Sundry Print Report

Well Name: CBM A POD 13 K

### **Notice of Intent**

Type of Action: Plug and Abandonment

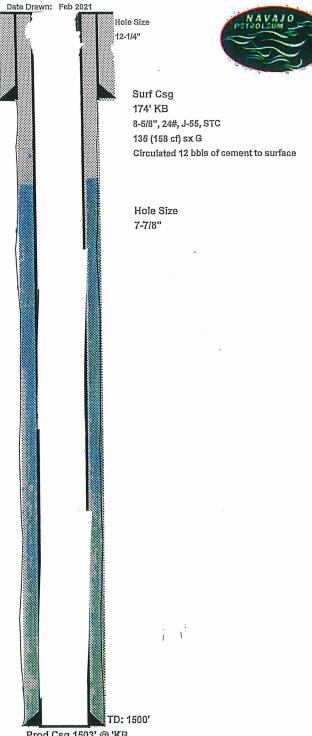
- No well log available for the subject well, tops were estimated based on well logs for Reference Well #1.
- BLM formation top estimates vary slightly from Operator estimates.
- Plug #2 (Fruitland) is too shallow to cover BLM estimated formation top. Please add a plug to cover BLM Fruitland top estimate @ 961'.
- Recommend adjusting Plug #3 (Surface) to extend 50' below the surface casing shoe @ 174'.
- This well was never completed.

- 1. Plugging operations authorized are subject to the attached "General Requirements for Permanent Abandonment of Wells on Federal and Indian Lease."
- 2. Farmington Office is to be notified at least 24 hours before the plugging operations commence (505) 564-7750.
- 3. The following modifications to your plugging program are to be made:
  - 1. Plug 2 is too shallow to cover BLM estimated formation top for the Fruitland. Add a plug to cover BLM Fruitland top estimate at 961 feet.
  - 2. Include a plug to cover 50 feet below or above the surface casing shoe at 174 feet. Or adjust Plug 3.

You are also required to place cement excesses per 4.2 and 4.4 of the attached General Requirements.
